Latch Change On Quicksilver Paralift Hydraulic Jack Plate

IDENTIFICATION OF LIFTING PUMP

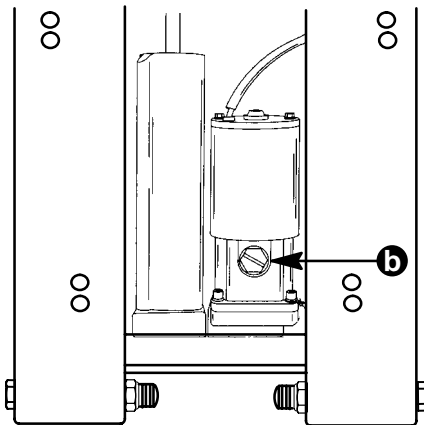
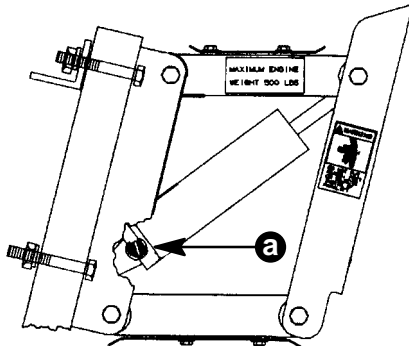
EATON LIFTING PUMP ASSEMBLY: Oil fill is located on the port side of the Paralift.

OILDYNE LIFTING PUMP ASSEMBLY: Oil fill is located on the transom side of the Paralift.

a - Eaton Lifting Pump Assembly with Oil Fill on Port Side of Paralift.

b - Oildyne Lifting Pump Assembly with Oil Fill on Transom Side of Paralift.

MEASURING TRAILERING LATCH

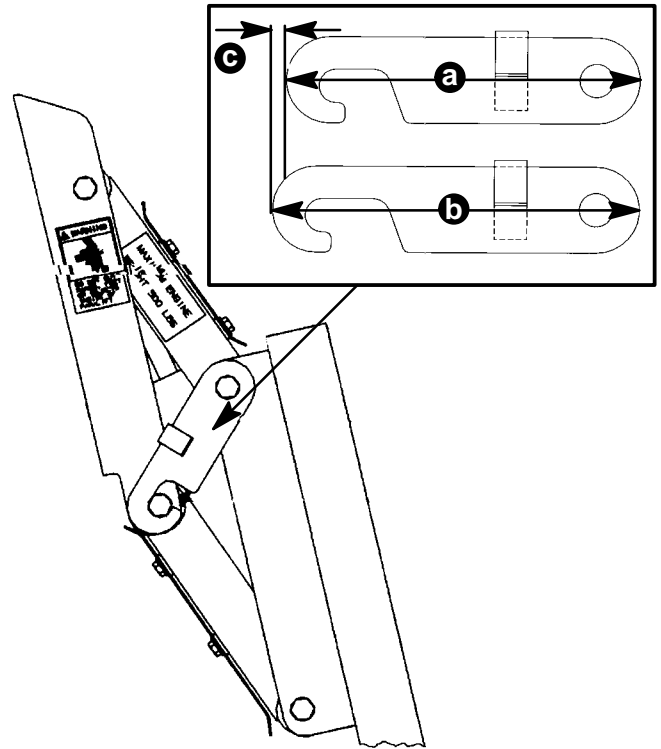
The trailering latch on the Quicksilver Paralift has been lengthened to accommodate the latest stroke of the hydraulic cylinder. If the lifting cylinder assembly is replaced on an older Paralift unit with the Oildyne assembly (See identification below), the latch will need to be changed. Also, there were some new Paralift units with Oildyne lifting assemblies that were mistakenly assembled with the original shorter latch.

a - Original Latch Measuring 8.150" (20.7 cm) in Length

b - New Latch Measuring 8.450" (21.5 cm) in Length

c - Total Length Difference Between Latches: 0.300" (7.6 mm)

Replacing an Eaton hydraulic cylinder assembly on an older Paralift unit with an Oildyne assembly: Order the longer latch P/N 821199--1.

Installing a new Paralift unit: Identify lifting cylinder assembly. If the lifting motor is an Oildyne, measure the latch to see if it is of the correct length. The latch should measure 8.450" (21.5 cm). Replace the latch under warranty if it is the shorter original version. Order P/N 821199--1.
